babcock & wilcox nuclear operations group

Subject: Reply to Request for Additional Information (TAC L33190)

ENCLOSURE 1
Reply to Request for Additional Information

The following questions were requested regarding B&W NOG's Amendment request to Chapter 9 (TAC L33190).

ENCLOSURE 2
Sanitary Wastewater System

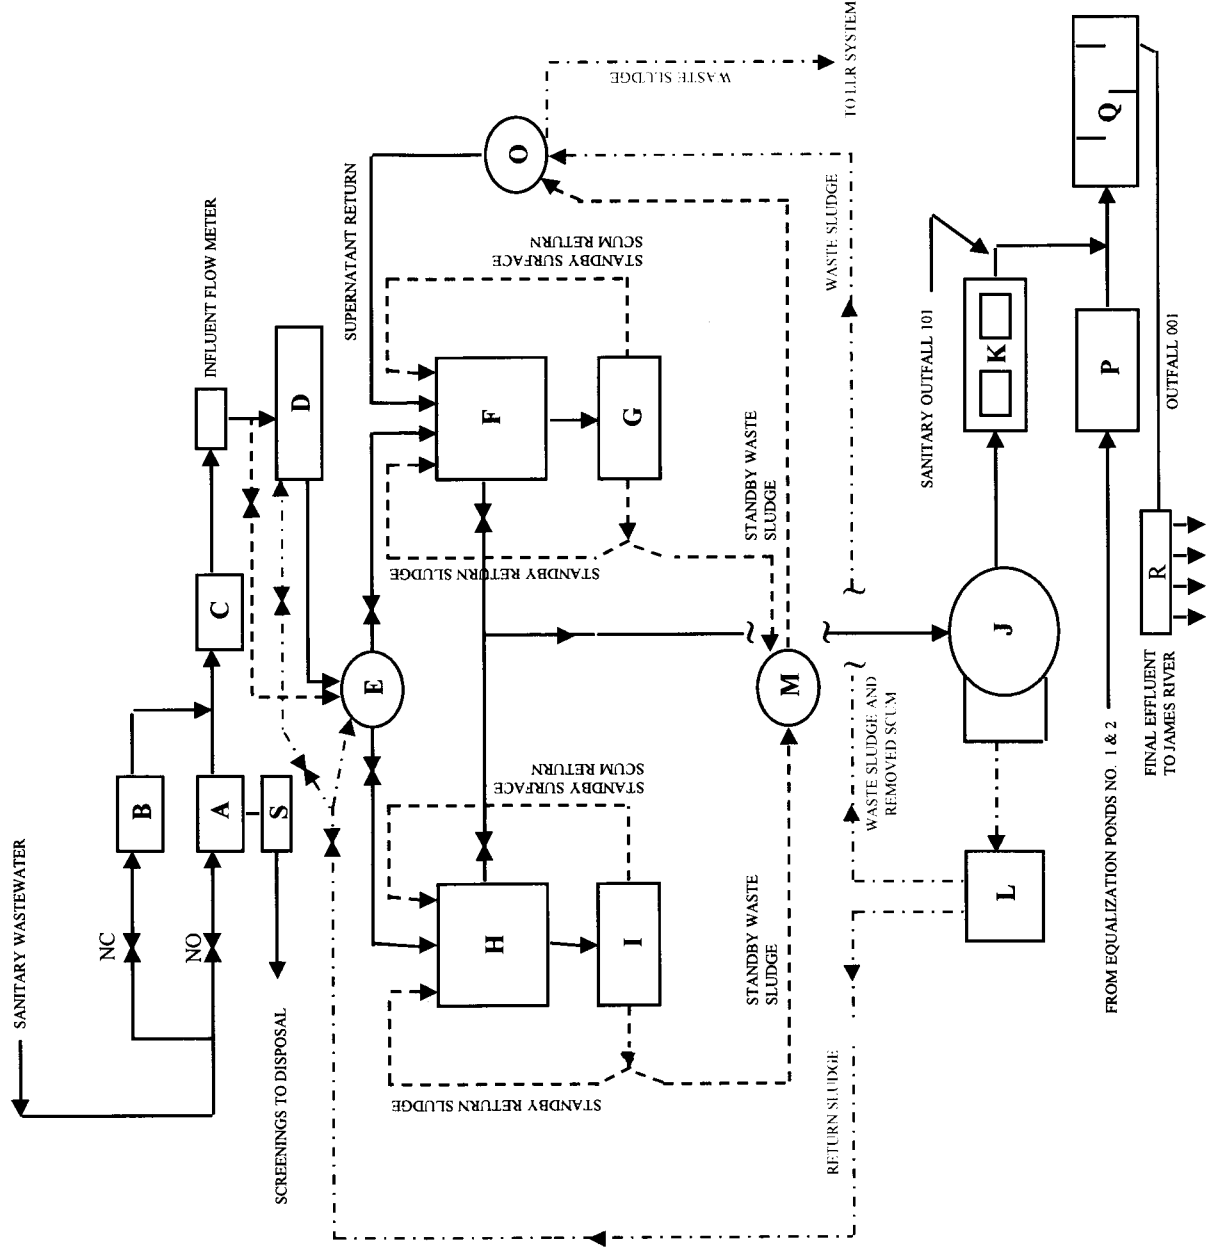
Please provide process descriptions (waste type and origin) and a brief description in the text of proposed paragraph 9.6.4, which ensures that the "...industrial or other waste treatment processes..." are not connected to the radioactive processes, and assurances that any new processes would be subject to the review and record keeping required by 10 CFR 70.72

The system is an activated sludge process. In the aeration tanks, microorganisms are mixed with the organic-laden wastewater. As the microorganisms grow, they clump together (flocculate) to form an active mass of microbial floc called activated sludge. Wastewater in the aeration tanks (or mixed liquor) is pumped into a clarifier for settling. In the clarifier, aggregated or flocculated solids, settle to the bottom of the tank and form a layer of concentrated sludge. Most of this sludge, (return sludge) is pumped back into the aeration tanks to facilitate the breakdown of organics. However, since the bacteria are constantly growing, some of the sludge eventually has to be removed from the system. Small amounts of sludge, referred to as waste sludge, are removed from the clarifier to a Sanitary Sludge Holding Tank (SSHT) for eventual disposal. A diagram of the Sanitary Treatment System is provided as Enclosure 2.

The sanitary treatment system consists of a mechanical bar screen, a screenings screw compactor, two lift pumps, a sock filter, a flow equalization tank, a flow splitter box, two aeration tanks, a sanitary circular clarifier, an ultraviolet disinfection system, a return/waste sludge pumping station, a sanitary sludge holding tank, and a mixing chamber.

Raw wastewater flows through the mechanical bar screen, removing floating and suspended materials, which are discharged to a screenings screw compactor, which de-waters, compacts and conveys screened solids to a drum for disposal as Rake Solids.

The wastewater is pumped through a flow meter and a sock filter, into the flow equalization tank. The wastewater is pumped into a splitter box, mixing the wastewater with return activated sludge (RAS) and then to the aeration tanks.

The mixed liquor flows to the clarifier. Most solids settle to the bottom. Floating solids and scum are scraped from the surface by a skimmer arm. The scum may be mixed with the RAS and routed to the secondary treatment process, or to the Sanitary Sludge Holding Tank (SSHT). Clear water flows to the Ultraviolet (UV) disinfection unit.

Sludge is scraped to the center sludge sump. Most sludge is pumped back to the splitter box as RAS. Periodically, sludge is pumped to the SSHT.

The SSHT has a gravity overflow that returns supernatant to the aeration tanks. Clarifier effluent flows to the UV unit.

Sanitary wastewater flow from the UV system to a mixing chamber combining with treated wastewaters. The effluent is discharged to the James River via a diffuser.
